August 16, 2022

Subject: Response to EGLE Comments and Addendum to the RCRA Interim Work Plan Investigation Report – Eastern Site Boundary; Former Hayes Lemmerz; Ferndale Michigan; MID 041 803 123; Waste Data System Number 395519
1600 West 8 Mile Road
Ferndale, Michigan

FIGURE 1

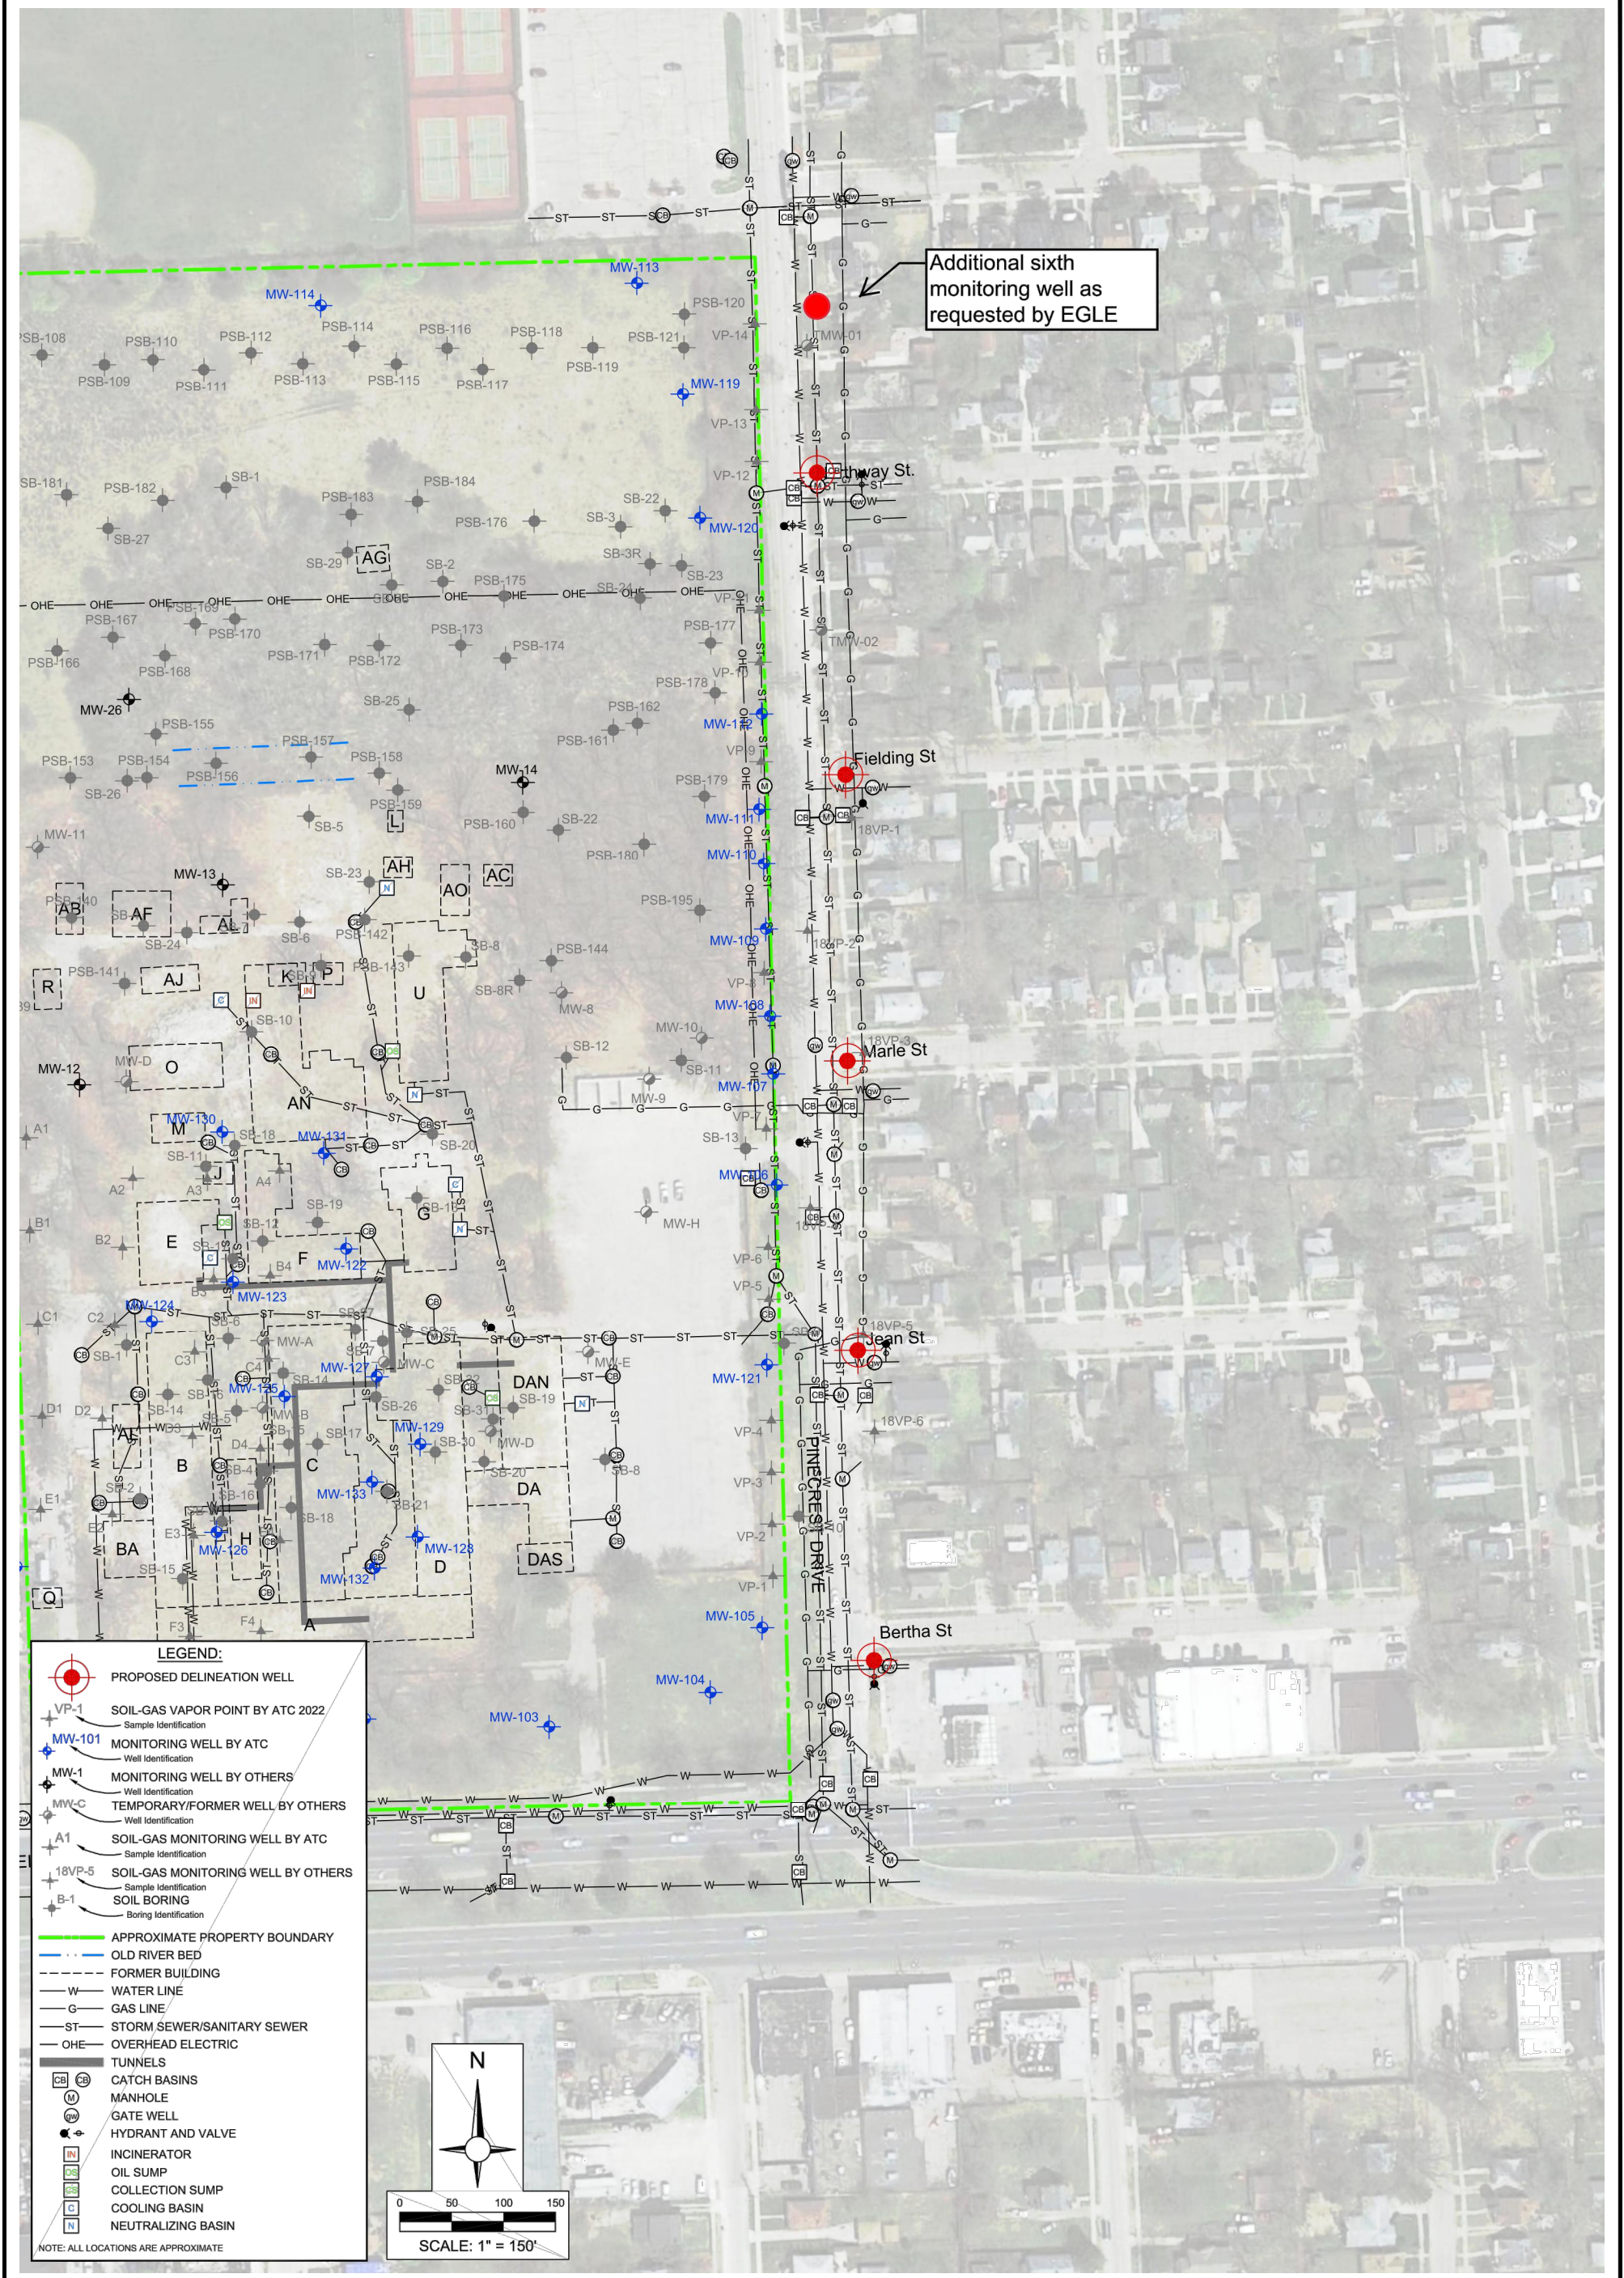
- b. Detroit Axle should consider revising the Report to add another new monitoring well, north of the northernmost proposed monitoring well, and between monitoring wells (MW) MW-113, and MW-119. This well is necessary in order to completely delineate off-site exceedances in groundwater.**

Additional sixth monitoring well as requested by EGLE

An additional well north of the northernmost proposed monitoring well, between MW-113 and MW-119 will be installed approximately as shown on **Figure 1** (exact location is subject to change based on field conditions).
